Ref: 14500.00

Re: Response to Peer Review Comment Letter  
425 Whitney Street

On behalf of Isomedix Operations Inc. (the "Applicant"), VHB is pleased to provide the following responses to the comments/questions raised in the peer review letter prepared by Environmental Partners (EP) dated February 25, 2021 regarding the proposed facility expansion located at 425 Whitney Street, Northborough (the "Project").

**C-2**  
Professional Engineer Seal  
14568.00

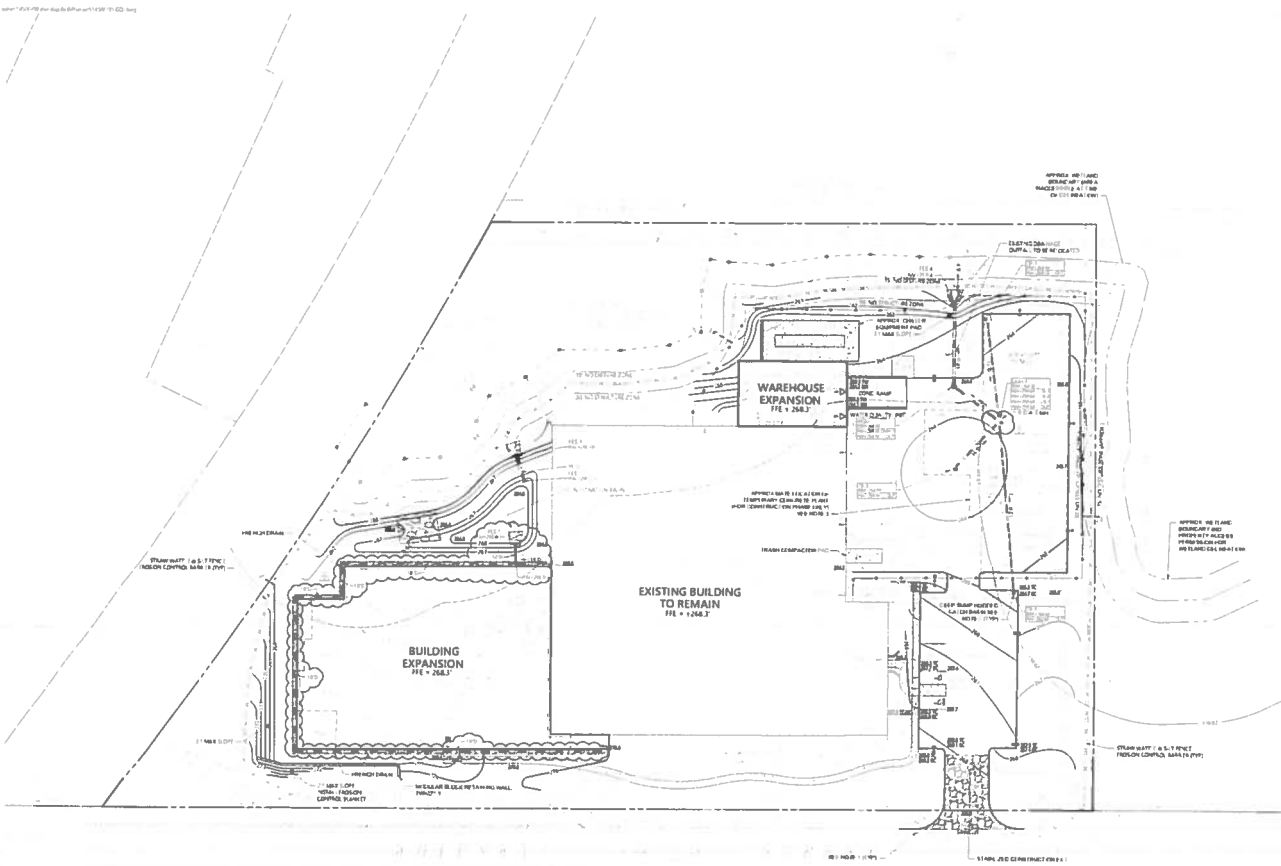
**Comment 13.** *Section 7-09-030 F (1) requires bicycle parking facilities be incorporated into the site design unless waived by the issuing authority. It does not appear that bicycle facilities are included on the plans. This section requires one bicycle parking stall for every 10 vehicular parking spaces. We recommend bicycle facilities be added to the plans consistent with the requirements of the Bylaw.*

**Comment 1.** *We recommend granite curb be installed at the site entrance along Whitney Street.*

**Response:** A bicycle rack has been added to the plan in accordance with the requirements of the Bylaw. See revised Site Plans attached hereto.

**Response:** The plans have been updated to reflect this change, see revised Site Plans attached hereto.

Not Approved for Construction  
 Grading, Drainage, and  
 Erosion Control Plan

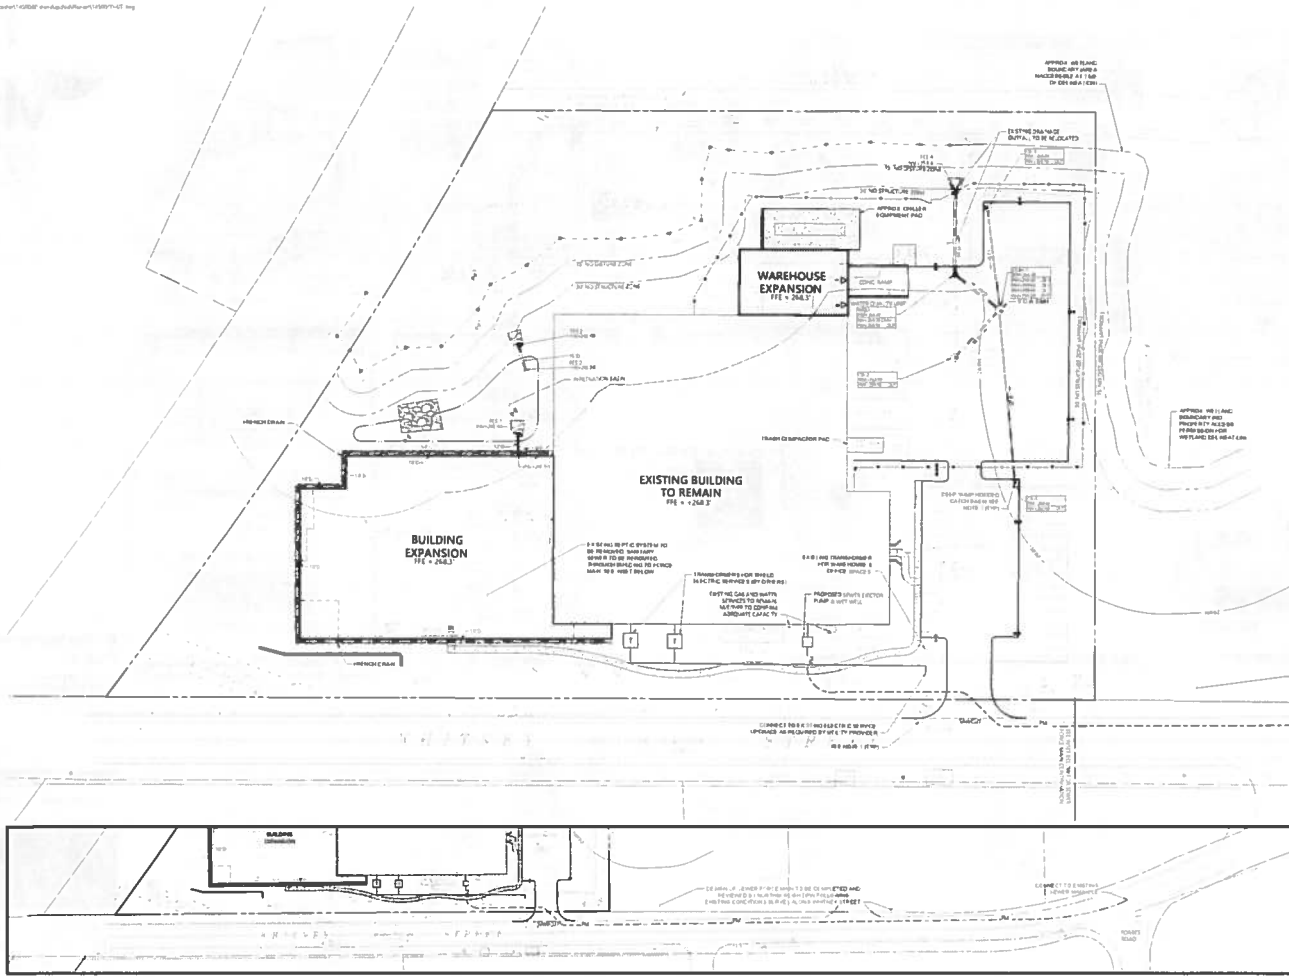
**Comment 1.** *We recommend the applicant add a note to the Grading, Drainage, and Erosion Control Plan to limit heavy machinery in the bottom of the infiltration basin.*

**Comment 3.** *Drain manhole 1 may need to be oversized given the configuration of piping into the manhole.*

**Response:** A note has been added to the grading, drainage, and erosion control plan to the effect of "Construction equipment, vehicular traffic, parking of vehicles, and stockpiling of construction materials shall be outside of the infiltration basin areas." See VHB's revised Site Plans attached hereto.

**Response:** Drain Manhole 1 (DMH-1) has been upsized to a 5' diameter manhole. This change has been reflected on VHB's revised site plans.

**French Drain**  
Scale: 1/4" = 1'-0"

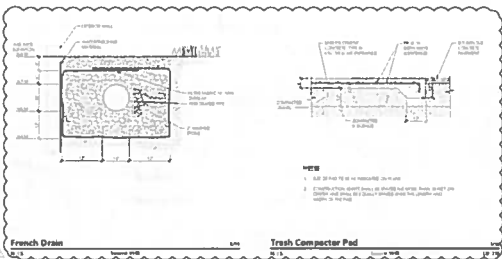
**Comment 5.** *The hydrologic drainage calculations show the french drain filling during the 10-year, 25 year, and 100-year storms. The 100 year storm shows the peak elevation in the french drain approximately 5 feet*

*higher than the top of the storage. The french drain is showing a higher outflow than inflow for the 25 and 100-year storms. We recommend the applicant verify and revise the modeling.*

**Response:** VHB has upsized the perforated pipe in the French Drain from 12" to 18". The size of the stone bed has increased as a result of this change. These modifications have been reflected in the French Drain detail shown on C-6. By upsizing the perforated pipe and expanding the stone bed, the French Drain has sufficient storage for runoff in all storms and the inflow is now greater than the outflow.
